MEADOWBROOK PARK

CIVIL CONSTRUCTION DOCUMENTS

PCD FILING NO. SF-21-025

STORM SEWER LINE C PLAN VIEW

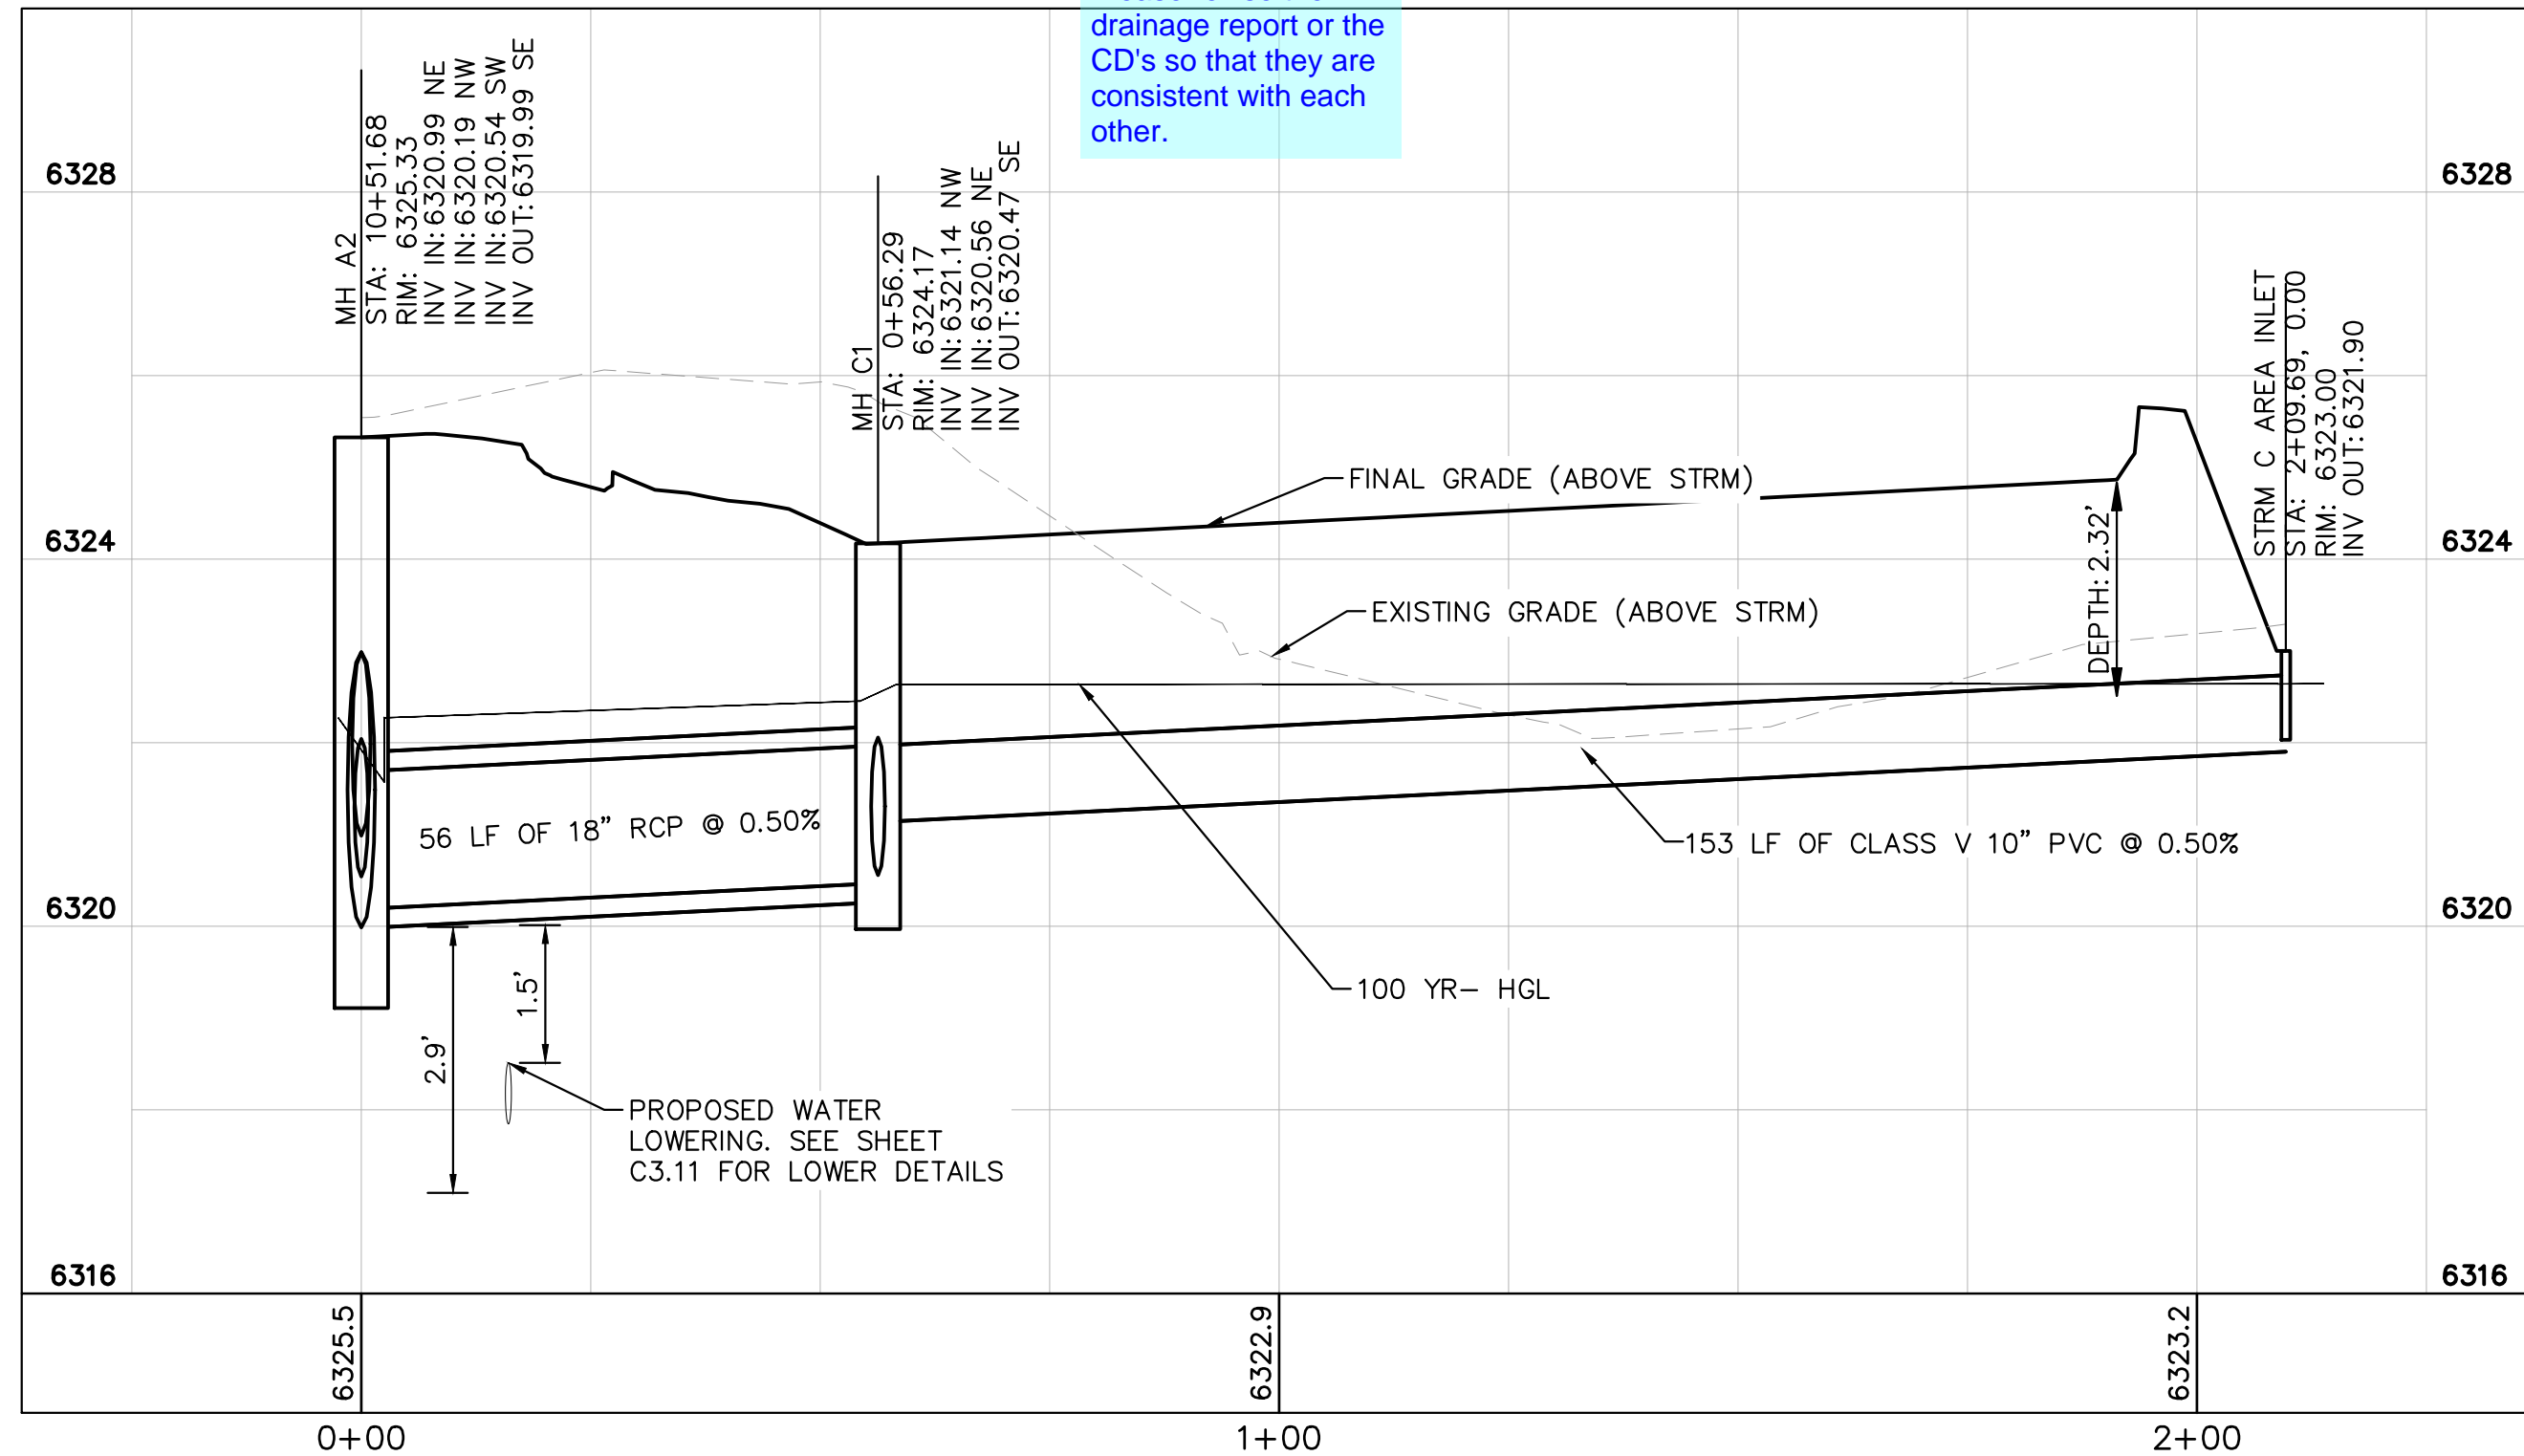
review 2 comment: the drainage plan indicates an 18" RCP. Revise so that they are consistent with each other
review 3 comment: The drainage plan indicates an 18" RCP. Please revise the drainage report or the CD's so that they are consistent with each other.

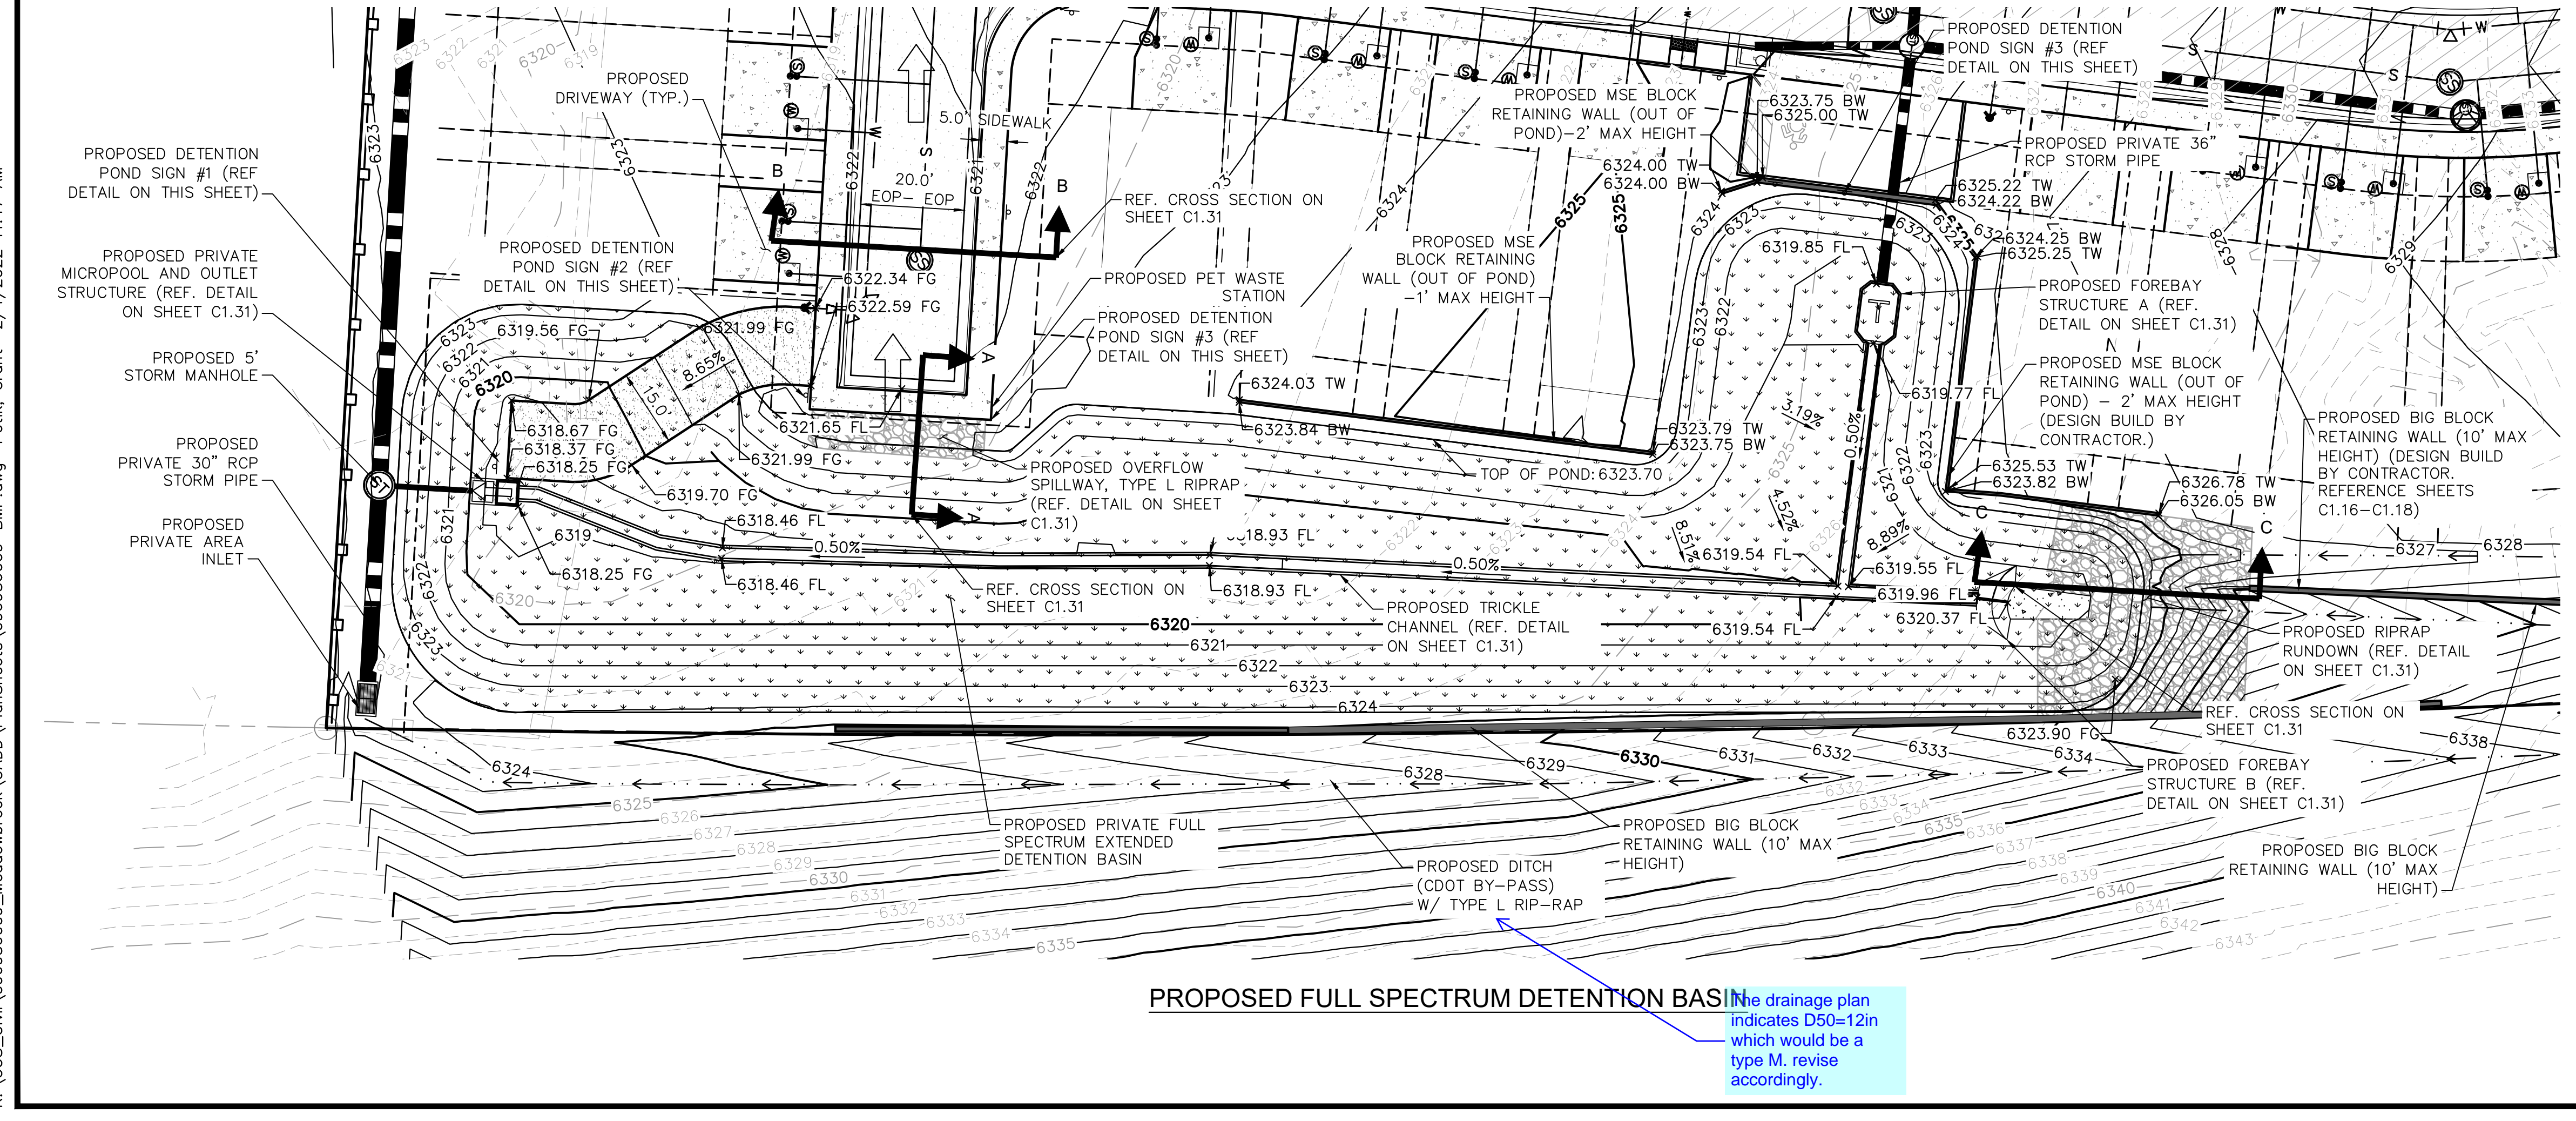
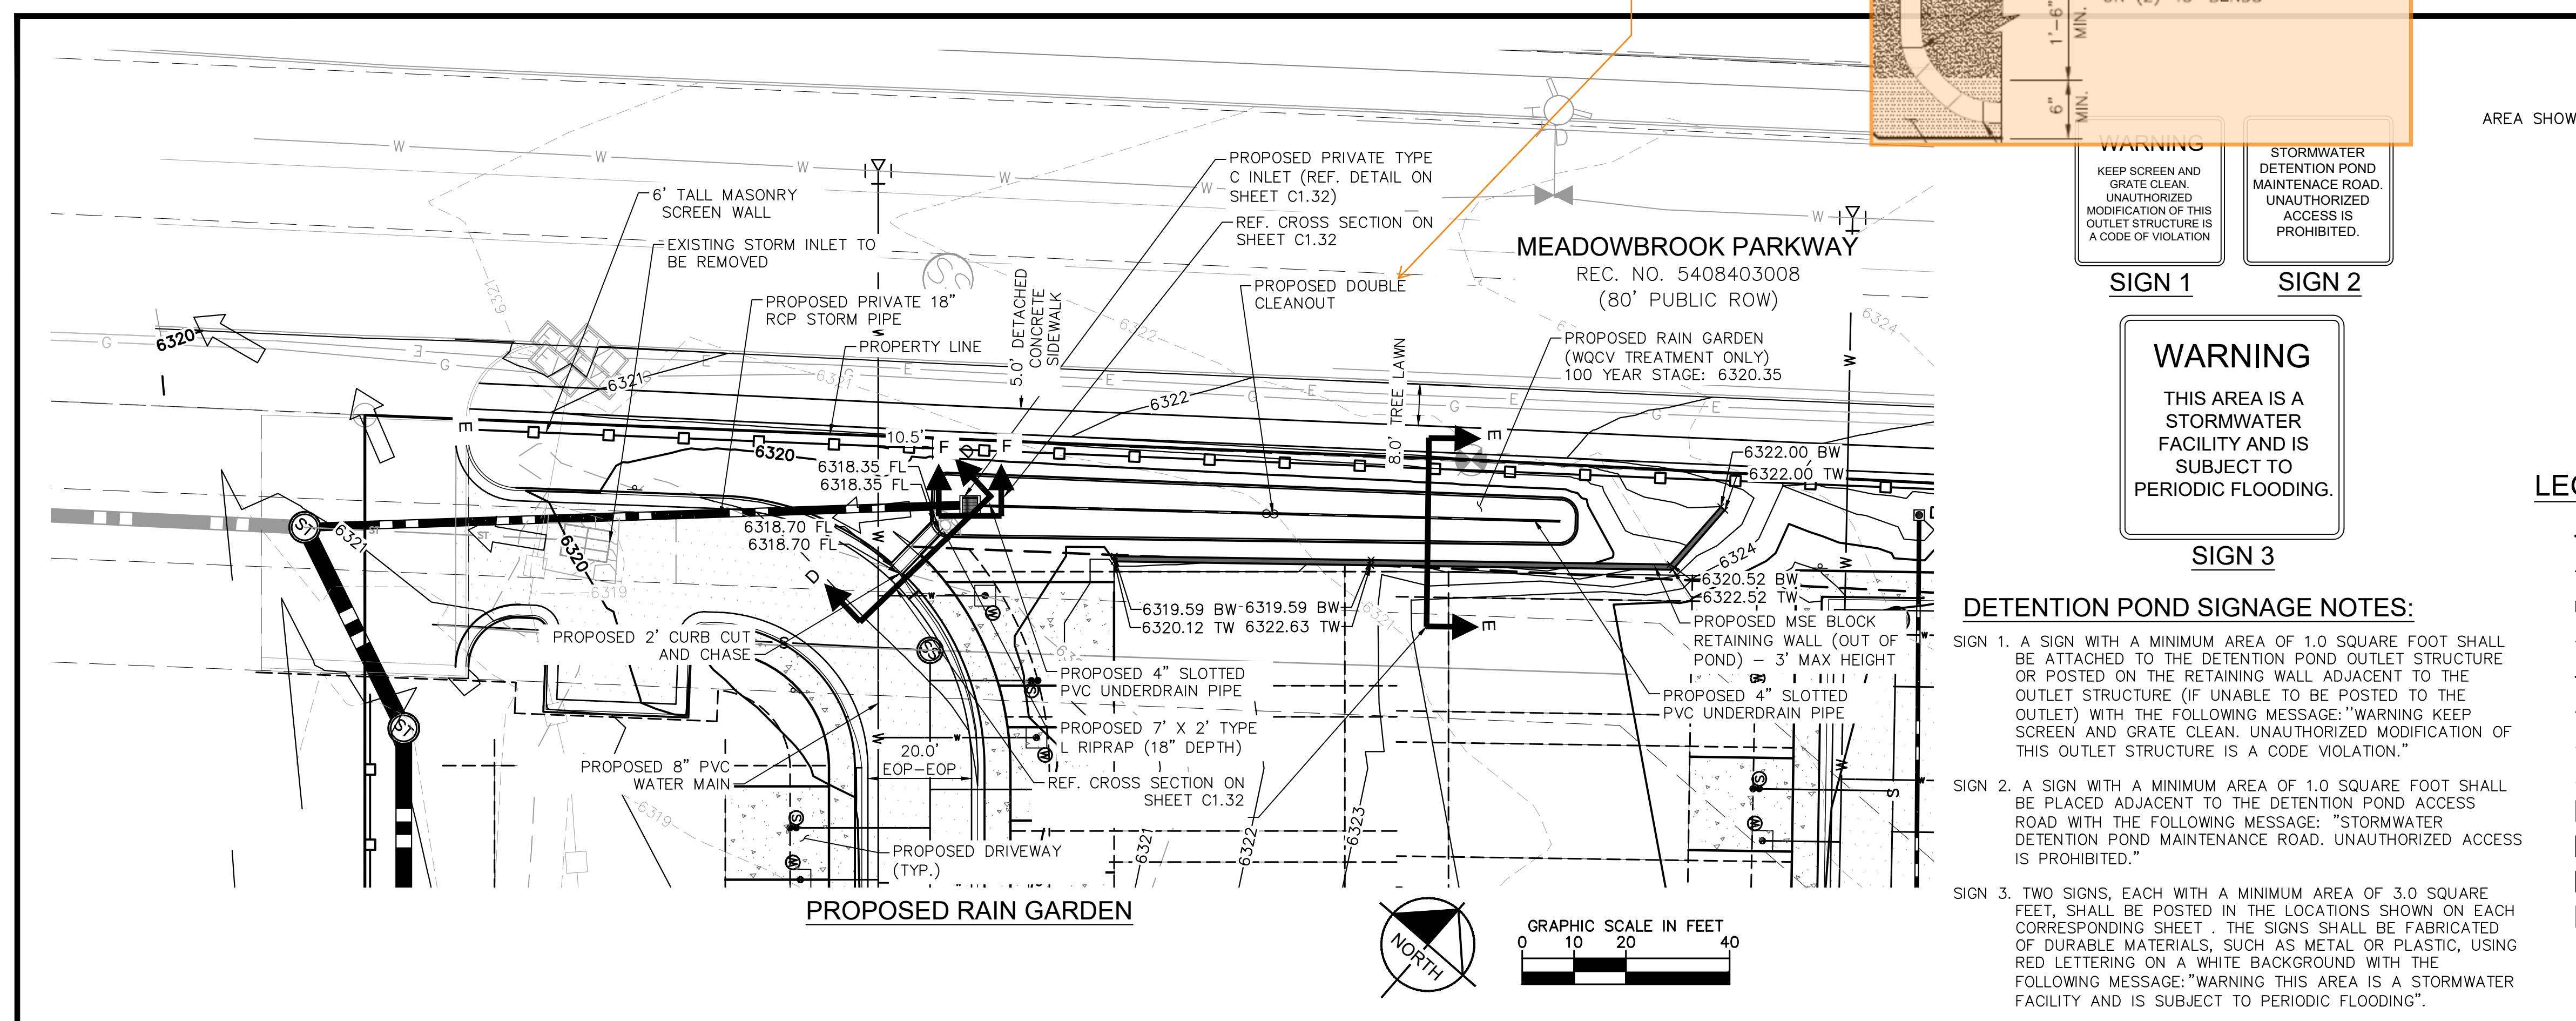
Review #1: Per MHFD Detail T-6, show and/or note that cleanouts will be with solid PVC pipe and provide a detail that shows 45's and cap as shown in graphic to the right.
 Review #2: Unresolved.
 Review #3: Unresolved.
